MONTGOMERY COUNTY HISTORIC PRESERVATION COMMISSION
STAFF REPORT

Address:	5605 York Ln., Bethesda	Meeting Date:	6/12/2019
Resource:	Contributing Resource Greenwich Forest Historic District	Report Date:	6/5/2019
Applicant:	Kathryn Becker Revocable Trust (David Schindel, Architect)	Public Notice:	5/29/2019
Review:	HAWP	Tax Credit:	N/A
Case Number:	35/165-19C	Staff:	Michael Kyne
PROPOSAL:	Demolition and new construction

Fig. 1: Subject property.

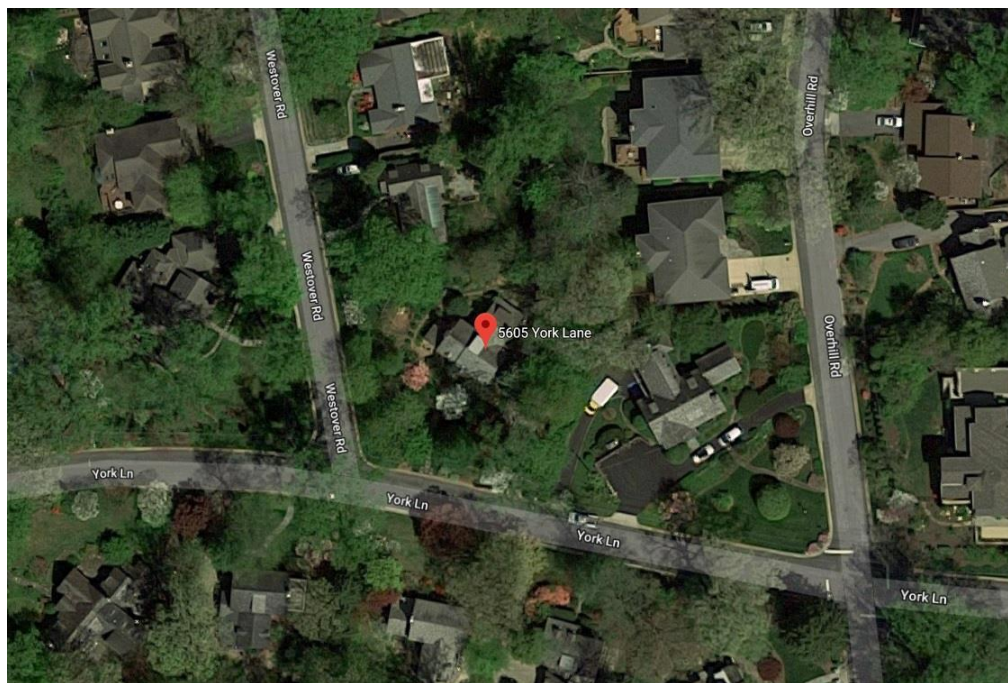
Most of the proposed work, including the rehabilitation of the existing front (south) and right (east) side porches, removal of all vinyl siding from the historic house, and masonry repointing consists of in-kind repairs and/or rehabilitation. Generally, this type of work does not require a HAWP; however, if any materials or features require complete replacement, they should be replaced in-kind in consultation with staff.

Staff finds that the replacement of original/traditional materials with alternative materials (i.e., fiber cement/Hardie, PVC, etc.) is inconsistent with the *Guidelines* and *Standards* and would not recommend approval of such a proposal. This applies to the front (south) and right (east) side porches, as well as any original siding under the vinyl siding, which is proposed to be removed from the house. Staff has asked the applicant to revise their proposal, removing any proposal to replace traditional materials with alternative materials (aside from the basement-level door, *see below*), and the applicant has agreed.

Regarding the proposed masonry repointing, staff finds that this work constitutes routine maintenance, but that the applicants should ensure that the composition of the new mortar is consistent with the existing. A mortar mixture with an inappropriate (i.e., “too hard”) composition will result in significant damage to the historic house within a short period of time. The existing mortar should be tested, and the test results and composition of the proposed mortar should be shared with staff before repointing commences.

Appendix 5.

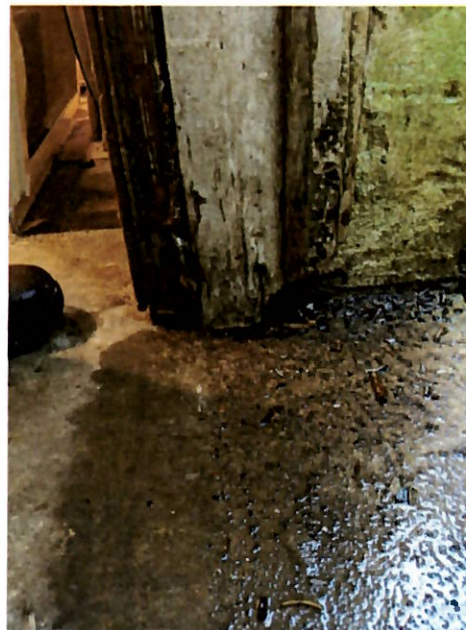
The applicant proposes to replace an existing wood basement-level door and doorframe at the right (east) side of the property with a fiberglass door and composite doorframe. The basement-level door and doorframe to be replaced are below grade, and they are not visible from the public right-of-way. Therefore, in accordance with the *Guidelines*, the proposed replacement should be reviewed with lenient scrutiny. Staff finds that the proposed door and doorframe replacement will not detract from the character-defining features of the subject property or the surrounding streetscape.

D4
A1
EXISTING/DEMO PLAN
1/4" = 1" - 0"

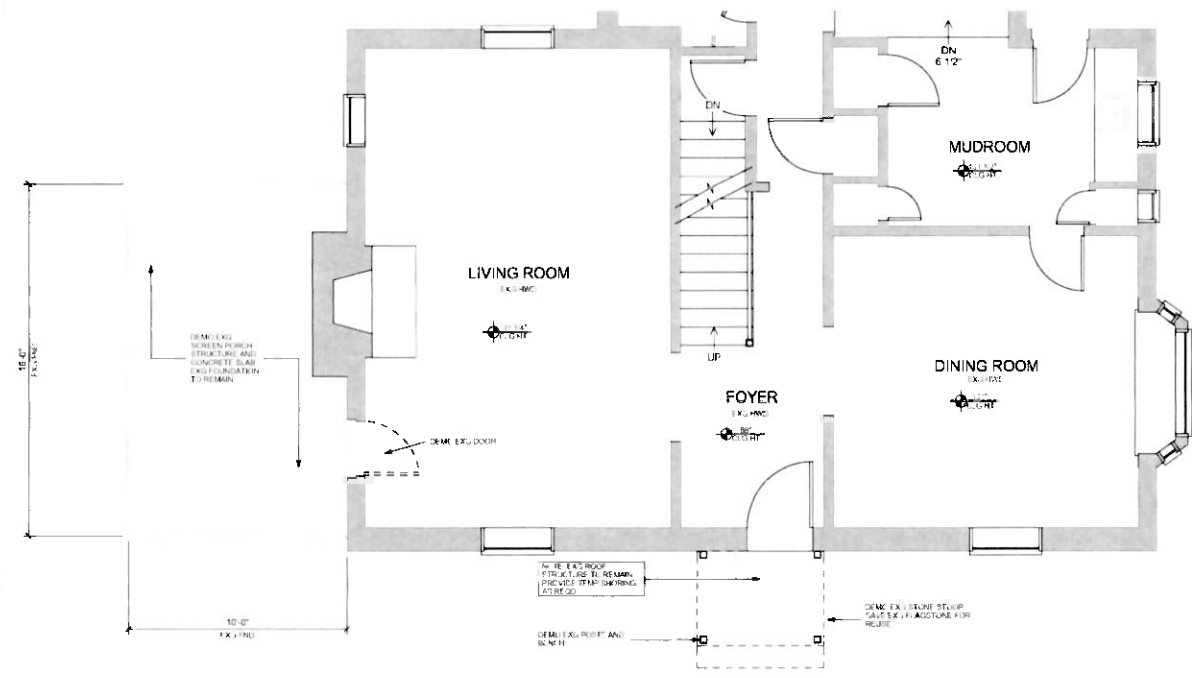
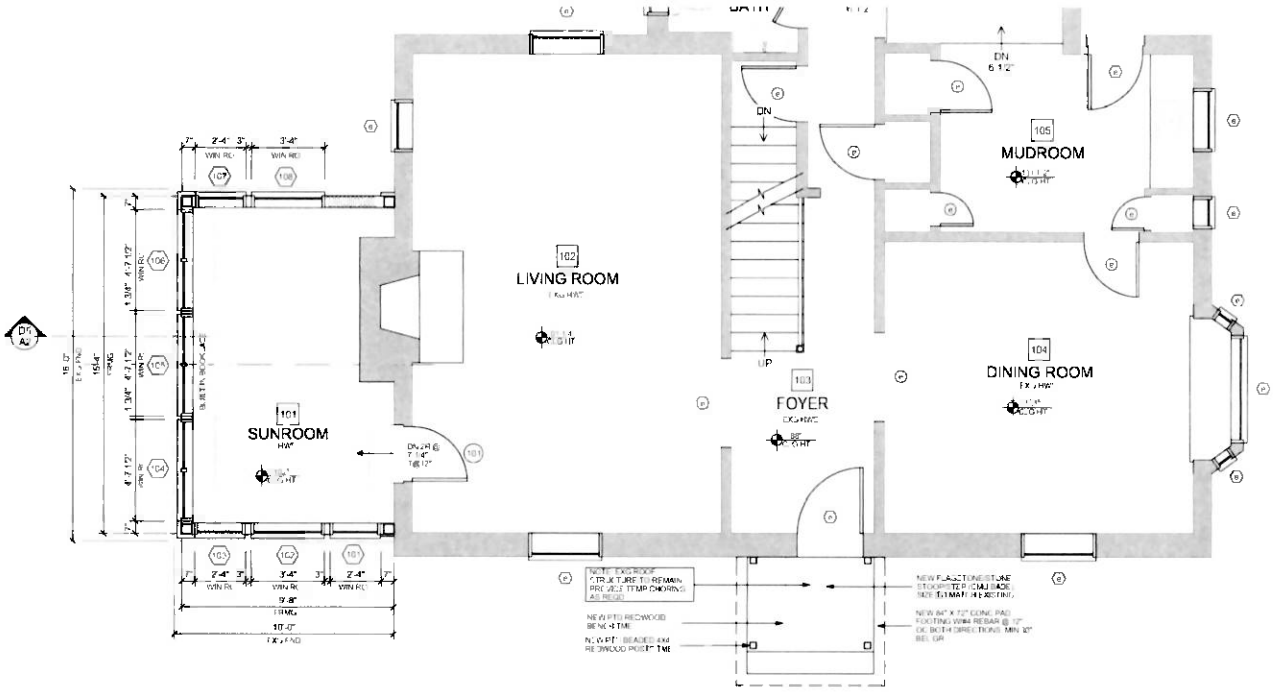
Staff is generally supportive of the applicant’s proposal to convert the existing screened porch at the left (west) side of the historic house to a study. As noted in the *Guidelines*, “[e]nclosures of existing side and rear porches have occurred throughout Greenwich Forest and they are permitted, subject to the decision-making body’s review of the work permit, to ensure that they are compatibly designed.” Because the porch to be altered is visible from the public right-of-way, the *Guidelines* indicate that the proposal should be reviewed with strict scrutiny. Staff finds that the altered porch/study is compatibly designed, and it makes use of appropriate traditional materials, including standing seam copper roofing, wood pilasters and panels, and wood SDL casement windows.
